DA 26000407 | 260 FRANKLIN STREET, ADELAIDE

RE: 26000407 – 260 Franklin Street, Adelaide

Section - Sunshading Northern Facade - Jan 21 - 11-11pm 75°
 SECTIONS - SHADING scale 1 : 50

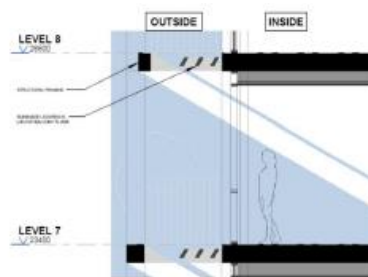
- *integrated external solar shading, particularly to east and west facing glazing and balcony edges*

Additional strategies have been implemented to shade the northern and western facades (plan and section pages). Where balconies are not provided on the northern side (centre) horizontal shading louvres are provided.

The number and angle of members is designed such that winter sun is not excluded. A similar strategy is utilised on the eastern and western facades where fixed shading devices are provided above windows where balconies are not present. Sunshades have separation gaps to allow abseil window cleaning access.

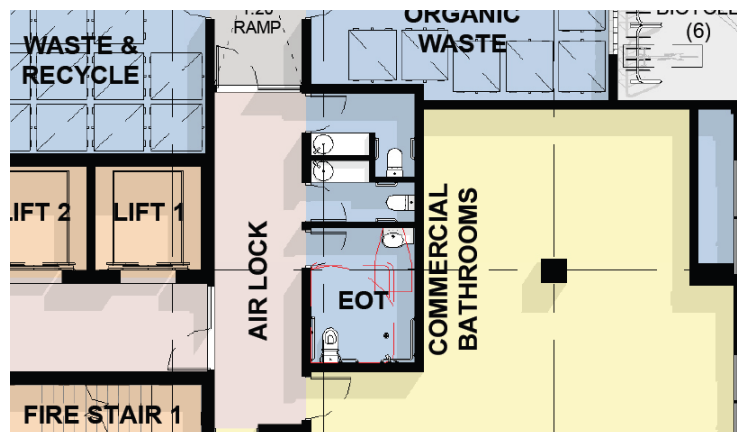
- The shortfall of 67 bicycle parking spaces is not supported End of trip facilities have not been provided for the retail component.*

Further, is also highlighted that the resident storage cages have been designed to fit many things, including bicycles, as demonstrated below.

Section - Sunshading Northern Facade - Jan 21 - 11-13pm 75°
SECTIONS - SHADING scale 1 : 50

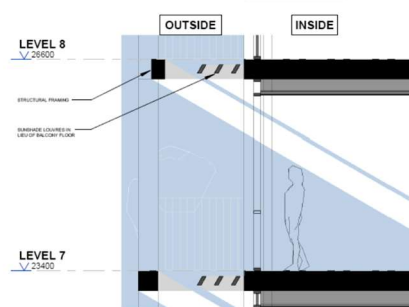
- Consideration of northern and western Shading Devices.

Additional strategies have been implemented to shade the northern and western facades (plan and section pages). Where balconies are not provided on the northern side (centre) horizontal shading louvres are provided.

The number and angle of members is designed such that winter sun is not excluded. A similar strategy is utilised on the eastern and western facades where fixed shading devices are provided above windows where balconies are not present. Sunshades have separation gaps to allow abseil window cleaning access.

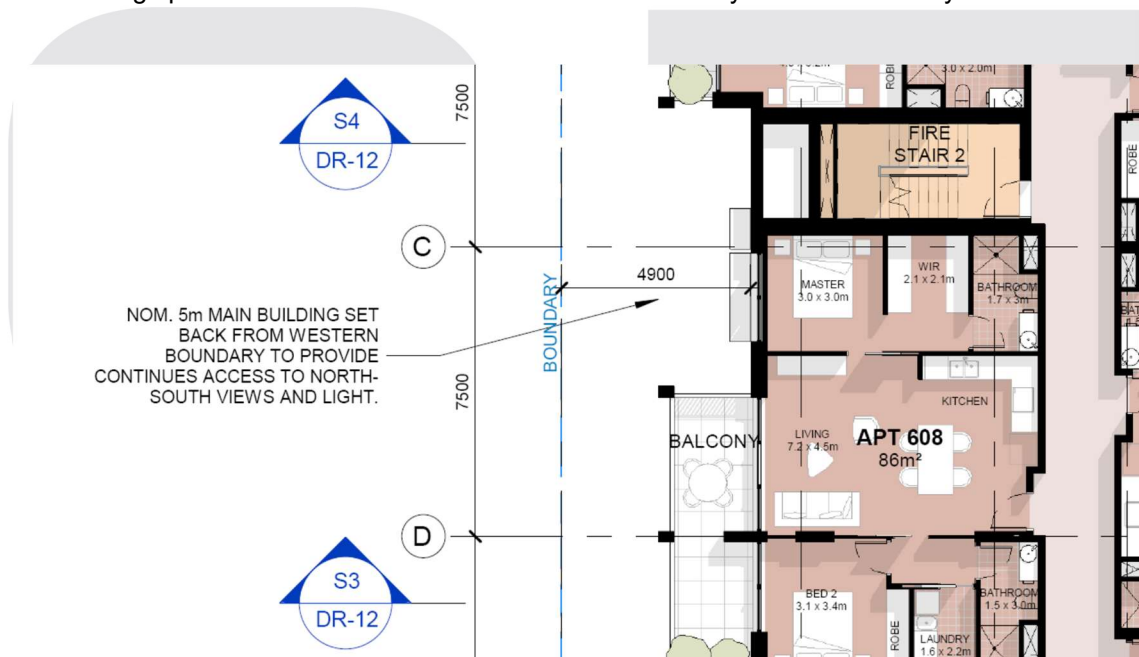
- Podium legibility

The podium establishes a strong, grounded base that forms a continuous built edge along the site boundary. It screens the car parking behind and contributes to a cohesive streetscape, responding to the scale of the apartment building to the east and anticipated future development to the west.

The tower above has been refined to draw colour and material cues from the podium, with selected vertical elements extended downward to visually connect the upper and lower forms. These interventions reinforce architectural continuity while preserving the distinct identity of each component.

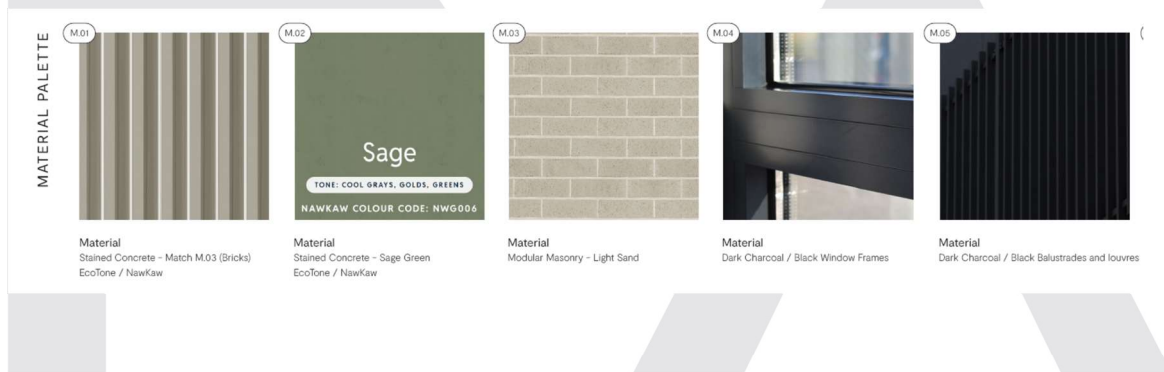
- Resolution of the grid, materiality and cohesive expression

Further refinement has been undertaken on the tower component of the building. The previously dark grey solid elements have been replaced with lighter, textured materials that reference the tonal qualities of the podium masonry. This lighter palette enhances visual contrast and reinforces the clarity of the tower’s structural grid.

Painted concrete components have been substituted with a concrete stain product. This method provides a longer lasting finish by preserving the breathability of the base material, reducing future maintenance. Precedents + Materiality page has been updated.

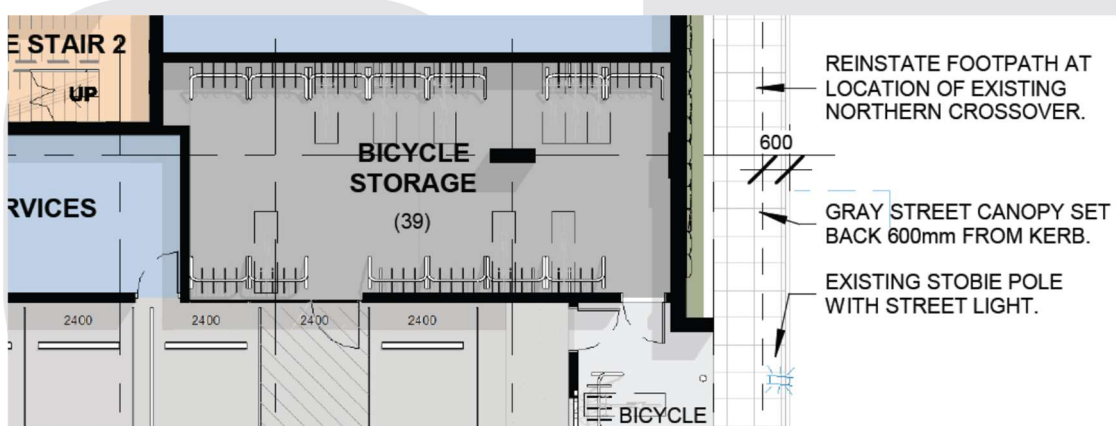
- Consideration of alternate bicycle parking location

Visitor bicycle parking has been reduced in number at the Gray Street location and four (4) spaces have relocated to the building’s main entrance.

Resident bicycle parking has been reconfigured to allow direct access from Gray Street without the need to enter the driveway.

Gray Street looking south - Car Park Entry, Services and Living Wall

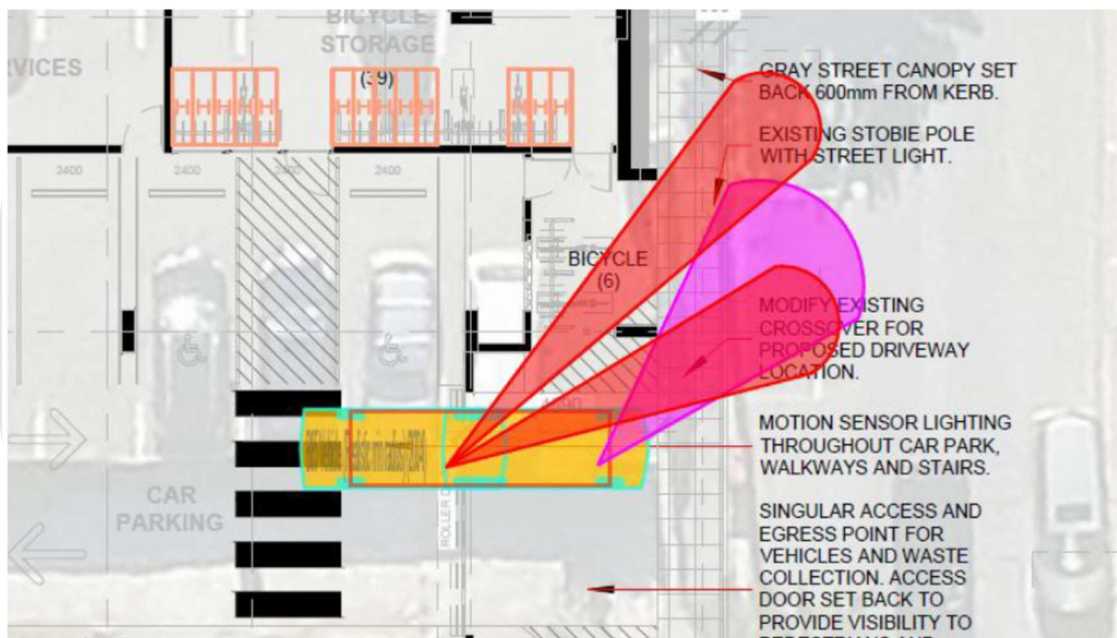
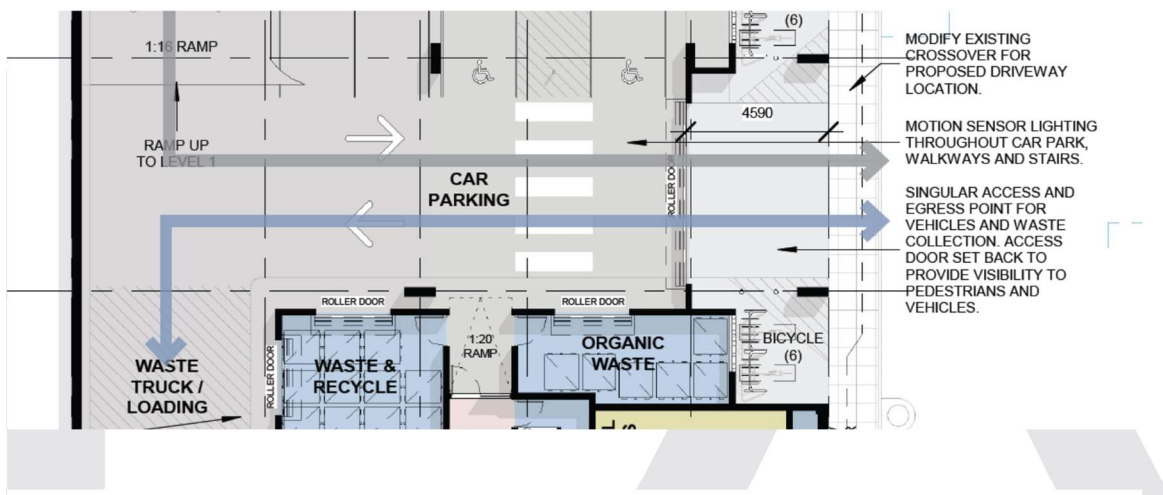
- Review opportunities to further activate Gray Street

The general characteristic of Gray Street is driveways, gates and roller doors with activation in the form of retail towards the Franklin Street (southern) end. The proposed development reinforces this pattern by introducing retail uses and extensive glazing along the southern portion of the frontage, complimenting the existing street character. Towards the northern end of the site, a green wall and seating area are incorporated to soften the interface and create opportunities for informal gathering and passive activation.

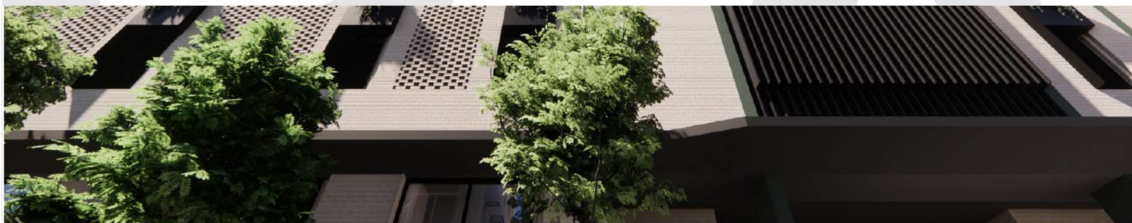
- Bicycle parking spaces and end of trip facility

The revised proposal increases the number of residential bicycle parking spaces and provides direct access from Gray Street. An End of Trip facility is not required as each apartment includes a bathroom.

View from Gray Street looking up

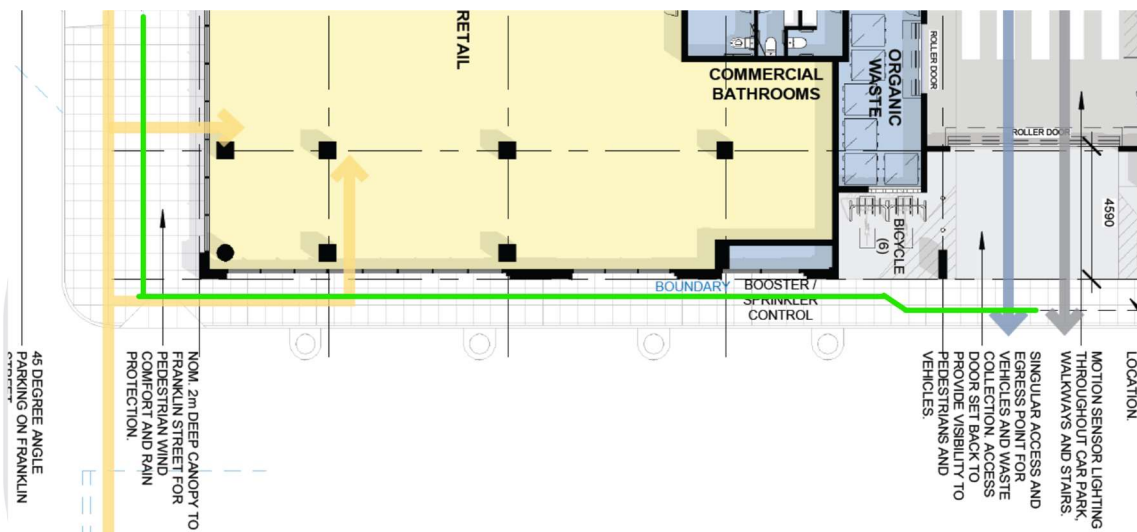
- Tree damaging activates due to canopy and canopy encroachments

The canopy depth along Gray Street has been considered in relation to pedestrian comfort, particularly wind and rain protection, as well as existing street trees. Along the southern end of Gray Street, the canopy in the vicinity of the street trees has been reduced to just 600mm off the building line, providing sufficient allowances for a gutter and lighting. At the vehicle access point the canopy has been set back 600mm from the kerb line to maintain appropriate clearance for tall vehicles. Please refer to updated Ground plan. Note that where the street trees are located, the canopy is pulled back off the kerb even further to accommodate the street trees.

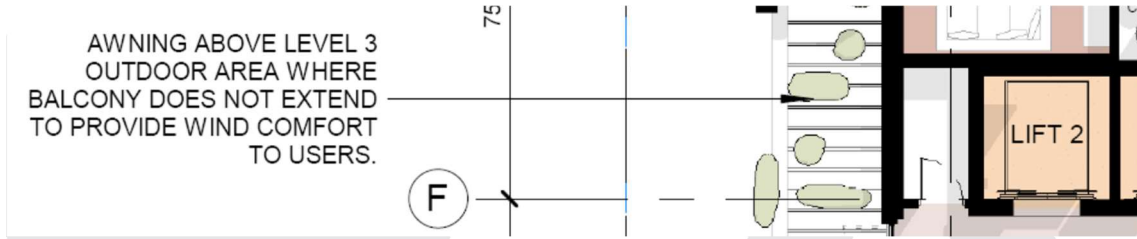
- Wind report awning to level 3 communal area

In most instances, the balconies project beyond the façade above forming the 'awning', maintaining a consistent vertical alignment of outdoor spaces. Where this condition does not occur above the Level 3 communal area, a fixed louvred structure has been introduced to provide appropriate coverage and visual continuity. Refer to the building sections and the Level 4 plan (Grid F) for further detail.

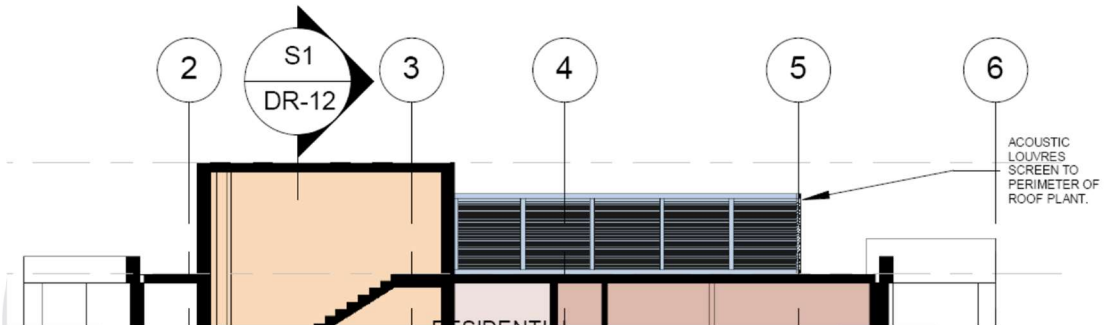
- Rooftop plant screen material and noise attenuation.

The rooftop plant will be screened by an acoustic louvre plant screen wall. Roof plans and sections have notes added to clarify.
